Safety Defect and Noncompliance Report Guide for Vehicles
PART 573 Defect and Noncompliance Report³

Odessa Industries dba: Overland Motor Coach
2208 MIDDLEBURY ST. ELKHART, IN 46516

99V-329 (04)

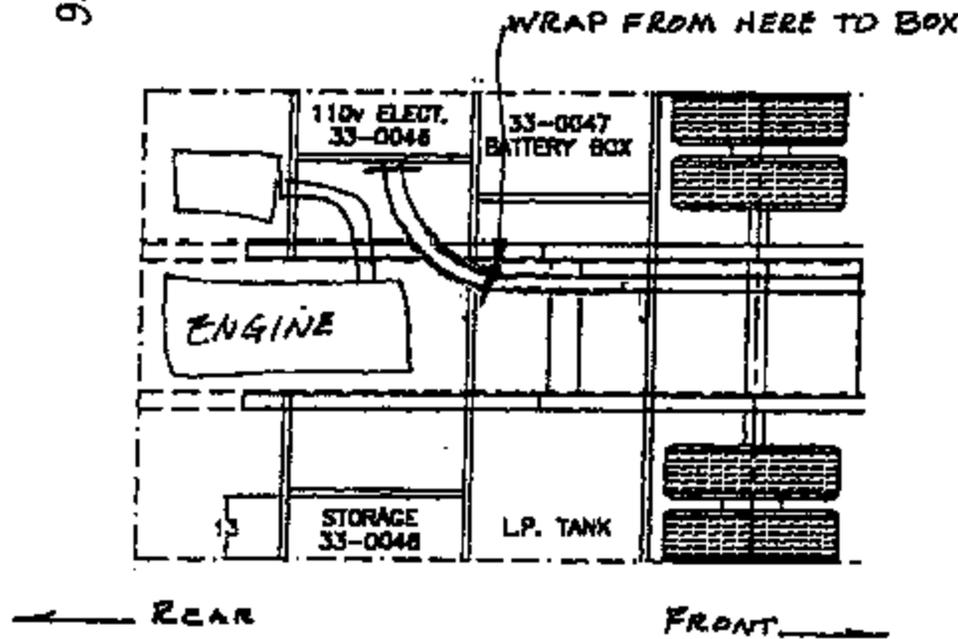
THE 110 WIRING FOR THE PANEL BOX THAT OPERATES THE 110 IN MOTOR HOME, IT IS RUN THROUGH THE ENGINE COMPARTMENT TO THE 110 PANEL COMPARTMENT

THE REASON IT IS A DEFECT IS BECAUSE THE ELECTRICAL CONDUIT WAS NOT WRAPPED WITH A HEAT SHIELD.

THE CONDUIT MAY GET TOO HOT AND BEGIN TO SAG. IF IT SAGS IT GETS TOO CLOSE TO THE EXHAUST AND WILL OVERHEAT THE COPPER WIRING INSIDE AND BURN.

The recall remedy will be the same as we are doing here in production. It consists of a wrap heat deflector, 2 clamp rings to install it, and 1 mounting clamp to reattach the conduit once wrapped up toward the frame.

RECALL CONDITION WAS IMPLEMENTED IN PRODUCTION ON NOVEMBER 18TH, 1999. WE ARE WRAPPING THE PIPE WITH DOUBLE SIDED REFLECTIX, CLAMPING THE REFLECTIX ON BOTH ENDS THEN ANCHORING THE PIPE UP AGAINST THE BOTTOM FLOOR AREA.

Left Run

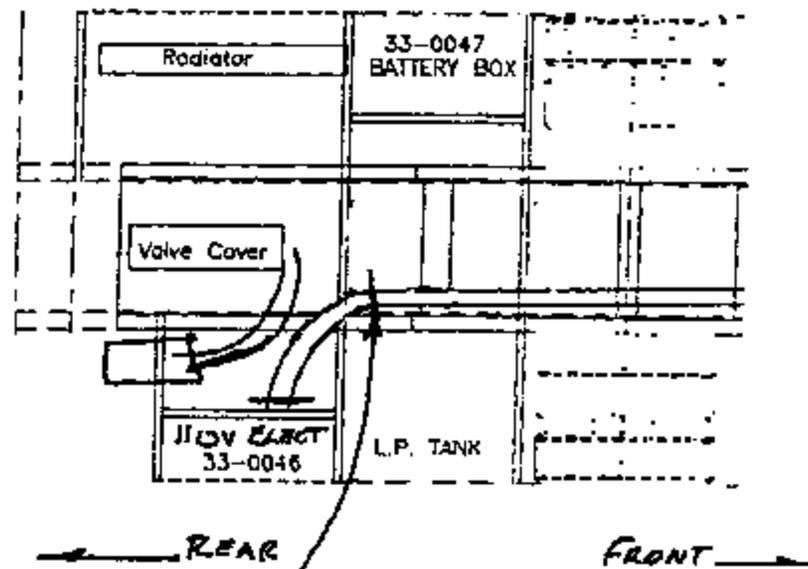
THESE UNITS ARE ALL DIESEL PUSHERS. THE CONDUIT RUNNING OVER MOTOR AREA WILL DIFFER FROM ONLY 4" EXPOSED AND UP TO 12" DEPENDING ON WHICH MODEL. IT IS EASILY IDENTIFIABLE. IT IS THE ONLY 3" PLASTIC ELECTRIC CONDUIT IN REAR. RUNS DIRECTLY TO BACK OF 110V PANEL BOX.
